I wish to object strongly to this application on the grounds that neighbour amenity will be significantly impacted.

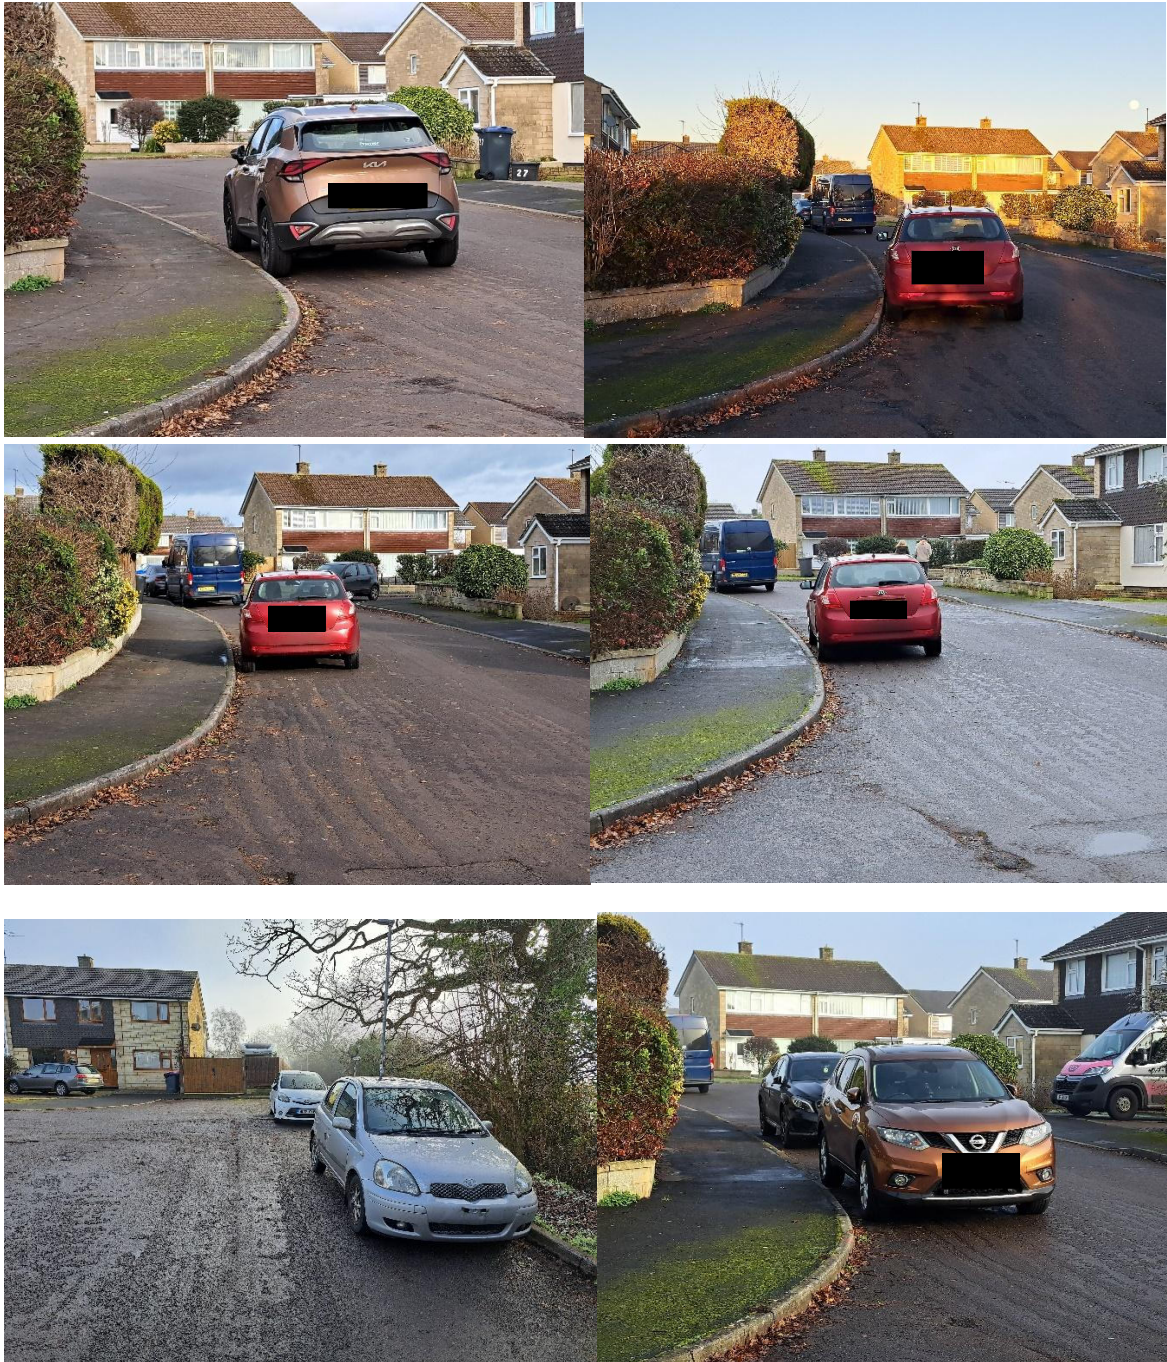
The proposed emergency access through Westmead Crescent will inevitably create “pinch points”. These points will prevent the access being passable without the implementation of a “no waiting” area which is fully policed.

Access to Westmead Crescent by a fire appliance could be through either Marston Road or Winterslow Road. Neither of these approaches has been considered important enough for a swept path analysis by the applicant.

The applicant attaches documents referring to swept path analysis on the new build. However, there is no such swept path analysis supplied with respect to the current built form. The only nod in the direction of this vital issue is within the document named “statement of compliance” on page 27. This clearly shows that a fire appliance can only enter the emergency access by mounting two pavements:

However, in order for this odd manoeuvre to be possible, all parking rights outside their own properties, currently enjoyed by residents will have to be removed. The following images are taken on four separate days, and serve to demonstrate that the removal of these amenities i.e. the right to park outside their own property, would have to be permanently removed.

Given that a ready-made access exists to the East of the site, along Axe and Cleaver Lane (a notified bridleway) it would seem to make far more sense for the layout of the application to be modified to allow that to become the emergency access for fire and ambulance services.

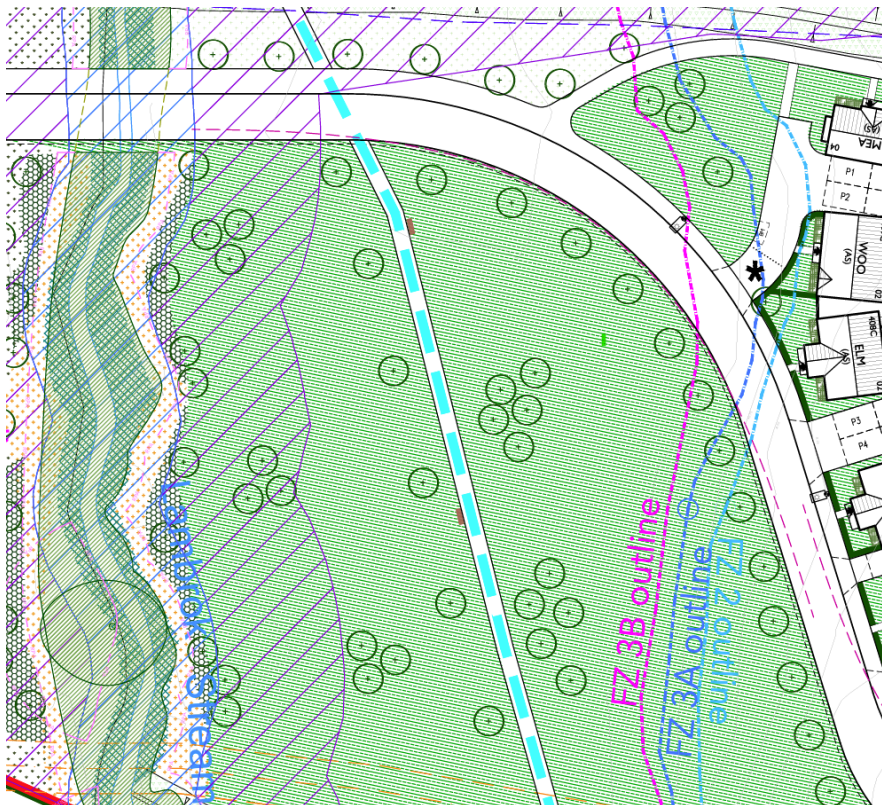
Furthermore, the original Outline application made great stock of the cycleway connectivity of the site. At appeal, those claims were dismissed as fantasy. One suggestion was to use the current footpath along Boundary Walk as a shared foot/cycleway, however, a site inspection confirmed that not only was cycling prohibited, but that along the length of the path many sections were below 1.5m in width, and not reached the 3m minimum requirement. When that option was abandoned, the applicant chose to identify the footpath between Heddington Close and Bradley Road as their shared foot/cycleway. It was then pointed out that the maximum width of that footway was 1.3m narrowing to 90cm, and that cycles were also prohibited from using the pathway.

The current application now appears to offer no active travel options towards the identified employment area of the retail park and business park. On that basis, it would appear to be beholden upon Highways to re-calculate the vehicular impact on the Frome Road, since the loss of active travel options will create greater traffic, especially at peak times.
